ANN ARBOR PLANNING DEPARTMENT STAFF REPORT

For Planning Commission Meeting of January 22, 2009

930 Church Street Planned Project Site Plan

File No. PPSP08-009

2 ELEVATION - EAST N.T.S.

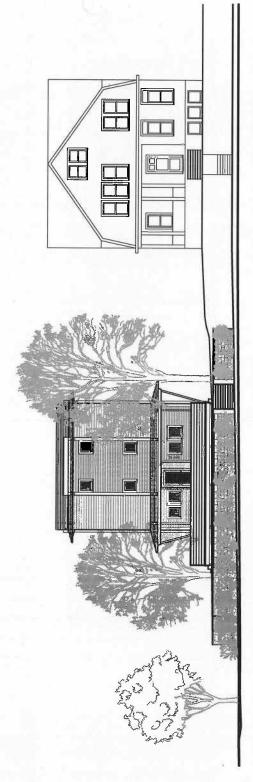
6. Attendees were opposed to the idea of galvanized steel.

8. Attendees asked if we could articulate the windows and add to the façade on the Church Street.

The material and design for that portion of the façade has been redesigned.

The design of the Church Street façade has been revised.
